MAMMOTH PACIFIC I REPLACEMENT PROJECT

FINAL ENVIRONMENTAL IMPACT REPORT

California Clearinghouse Number 2011022020

September 2012

FEIR Drawing 1: Possible Geothermal Power Plant Sites Located on LADWP Land Plotted on the Casa Diablo Area Plant Siting Constraints Map

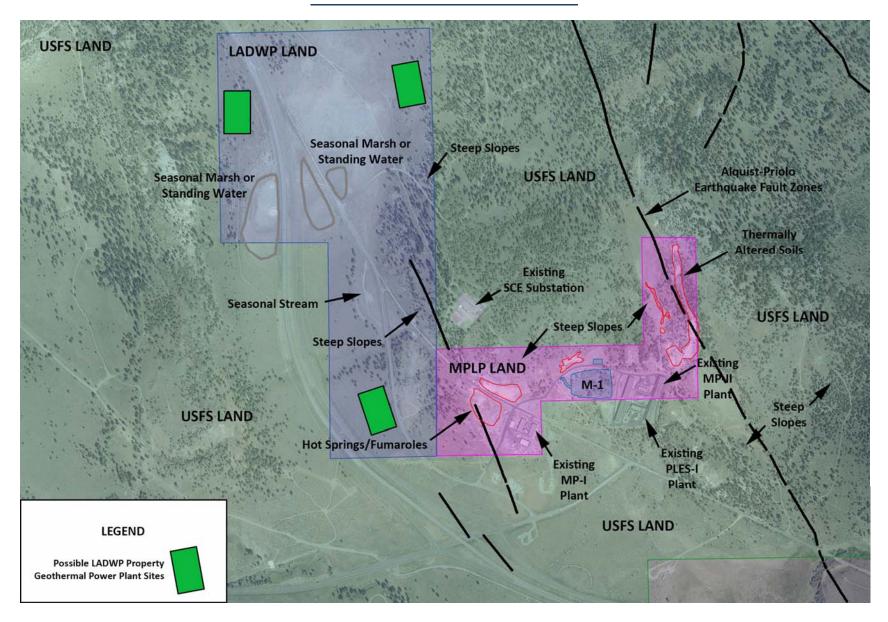
Comment 12-04 Summary: The commenter, continuing with the assertion that a General Plan Amendment is part of the proposed MP-I Replacement Plant Project, argues that the RDEIR2 does not analyze the secondary effects of the asserted General Plan Amendment portion of the Project.

Response to Comment 12-04: Contrary to the commenter's assertions, the RDEIR2 (at pp. 33-37) presents an analysis of the potential environmental impact of the County's proposed clarifying General Plan revisions, both with respect to the Project and with respect to other possible geothermal development at other sites subject to the 500-foot setback requirement.

With respect to the "LADWP" parcel, as is shown on Figure 39 of the RDEIR2, three potentially feasible locations exist that are each more than 500 feet from a blue-line watercourse and would thus represent potentially feasible locations for future geothermal power plant site development that would not require a variance from the 500-foot setback requirement. The commenter notes that several other factors, including economic considerations, could influence the proposed location of any future hypothetical geothermal development proposal at the "LADWP" parcel. However, none of the possible geothermal power plant sites shown on the LADWP land has the same constraints as those identified on the existing Casa Diablo geothermal complex project site. Specifically, they do not contain steep slopes, Alquist-Priolo fault zones or hot springs/fumaroles (see FEIR Drawing 1 showing the possible geothermal power plant sites located on the LADWP land plotted on the Plant Siting Constraints Map earlier provided as Figure 18 in the RDEIR). Thus, although other adverse environmental effects may be associated with locating future geothermal power production facilities on these sites, they do represent potentially feasible locations for future geothermal development outside the 500-foot stream setback that are not constrained by the conditions of the Project site. A variance is only available to the County's land development regulations if special circumstances applicable to the property deprive it of privileges enjoyed by other property in the vicinity and in an identical land use designation and if the grant of variance will not be injurious to property in the area. Because several feasible sites exist on the "LADWP" parcel, a variance would not be required or authorized. And the 500-foot setback does not apply on federally-owned lands within the Casa Diablo area, as such lands are outside of the jurisdiction of local land use authority. The text on p. 35 of the RDEIR2 has been revised to add this information (see Chapter 3, Compiled Revisions to the Draft EIR). As a result, the RDEIR2 does provide a sufficient basis for the conclusion that no significant impacts would result from the proposed General Plan revisions.
